The **City of Stoughton** will hold a joint meeting of the **Planning Commission and Business Park North Committee** on **Monday, June 13, 2011 at 5:30 pm**, in the **Council Chambers**, Second Floor, **Public Safety Building**, 321 S. Fourth Street, Stoughton WI.

**RE: Proposed Pharmacy Audit Assistance Services**

I have completed a review of the proposed new building at Park Place, 160 Business Park Circle - Plan submitted 6/7/11. As noted, additional information may be required to be provided or shown on the plan.

**1 PROPOSED SOUTHEAST ELEVATION**  
A-2.1 SCALE: 1/8" = 1'-0"

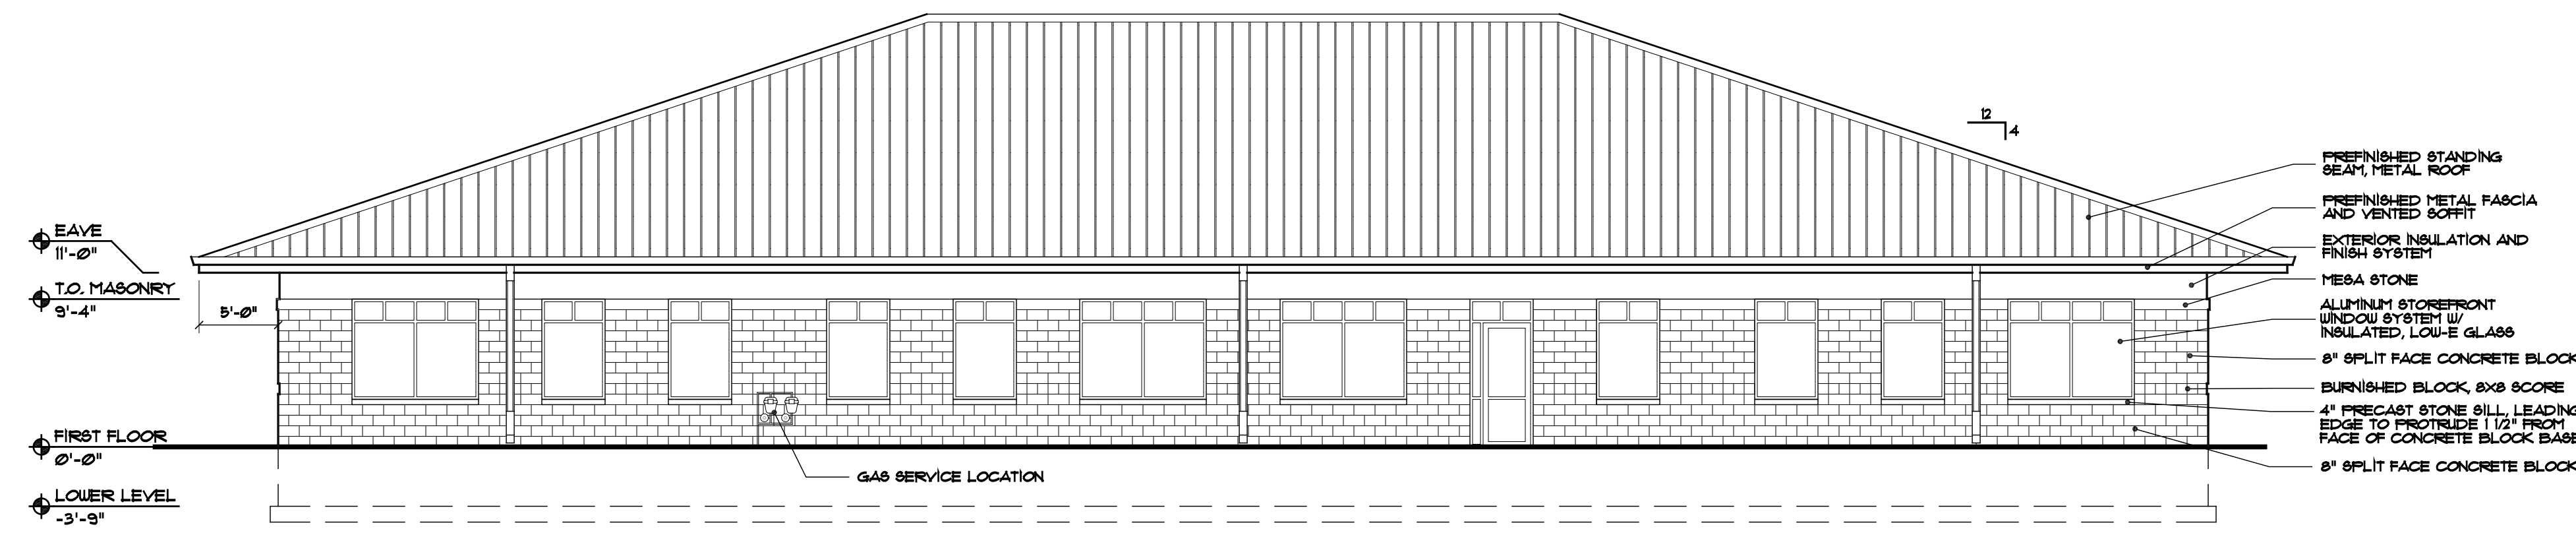
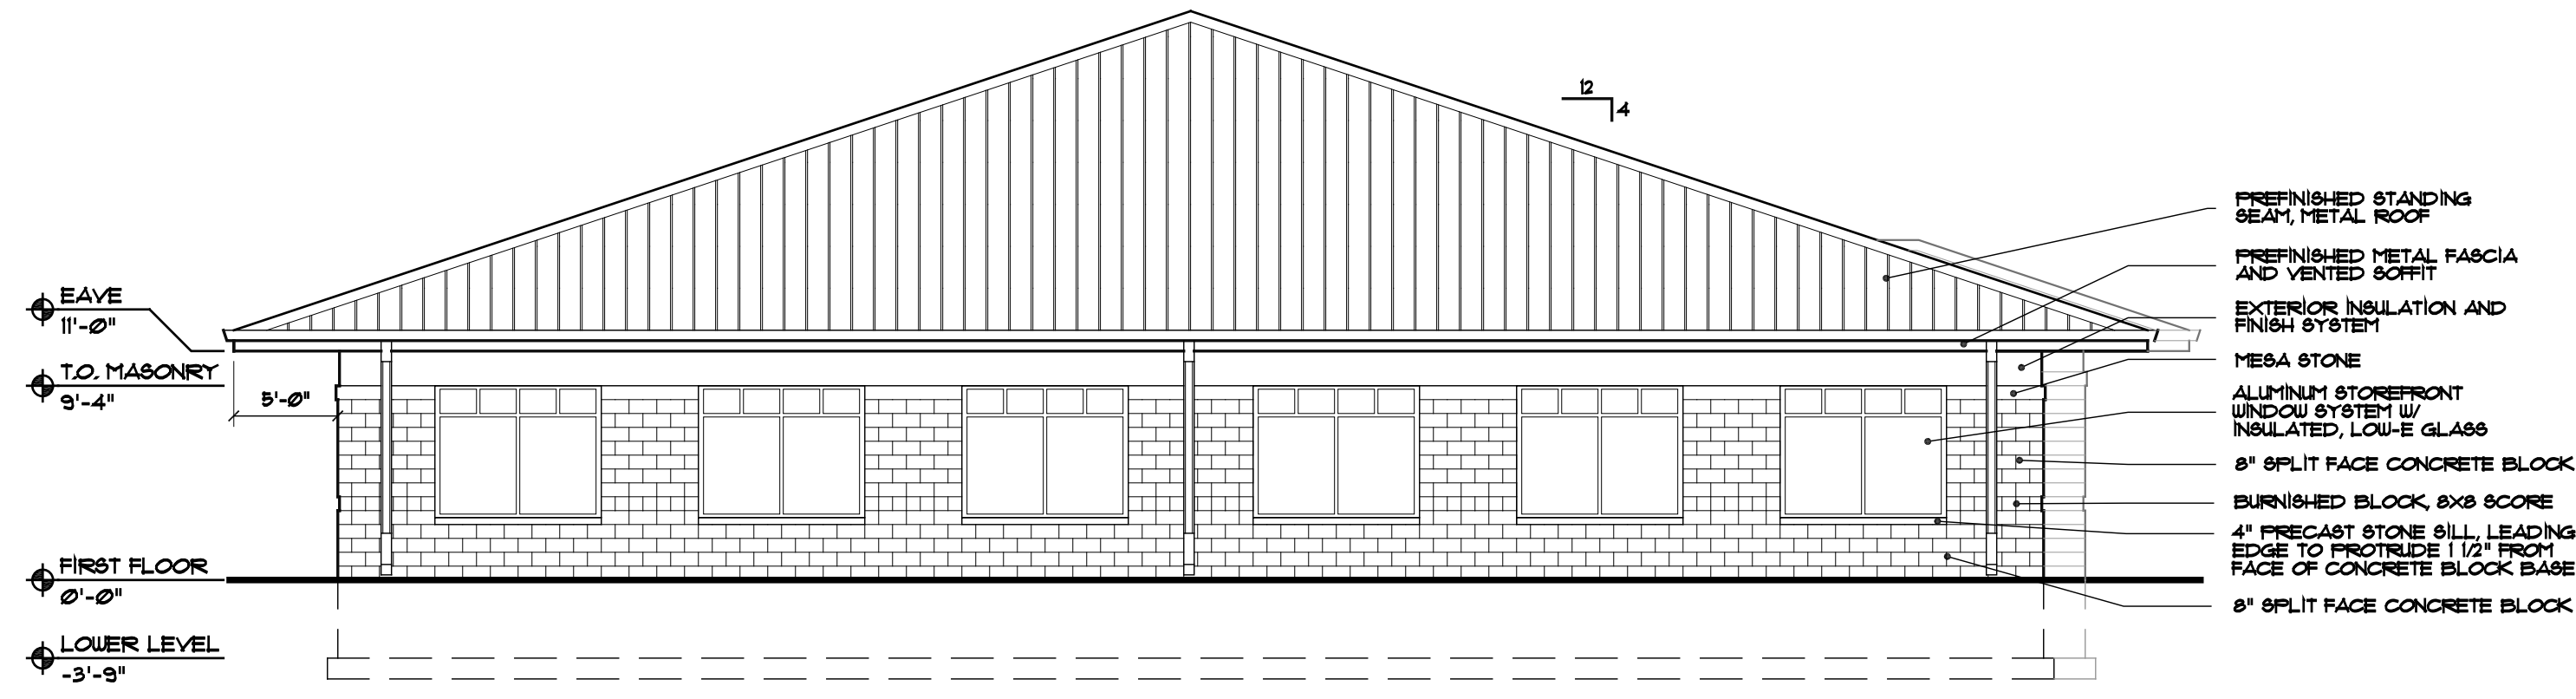
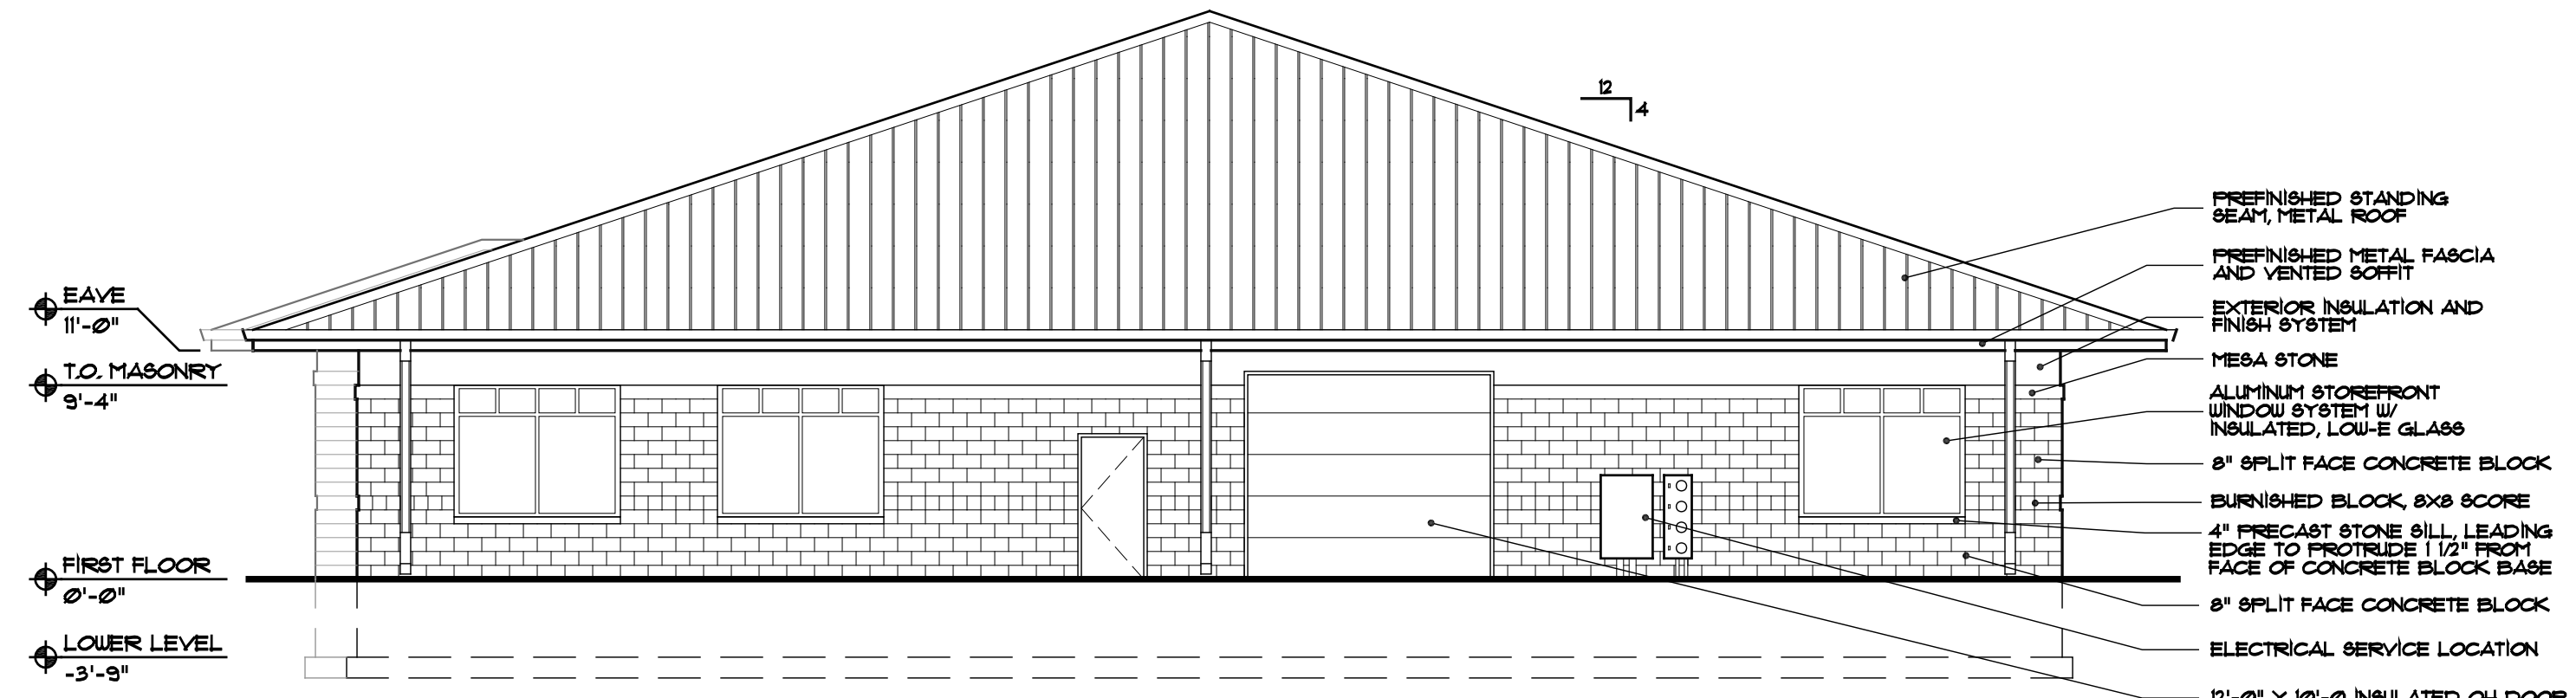
- g. All exterior materials and colors, including manufacturer’s name and catalogue numbers or samples of the same. **A color rendering or samples will need to be provided for the meeting**

- a. “All electrical and air conditioning structures, including towers and air handling units, regardless of location and whether on the roof or otherwise, shall be concealed by landscaping or by decorative screening materials which form an integral part of the design.” **This will need to be delineated on the plan.**
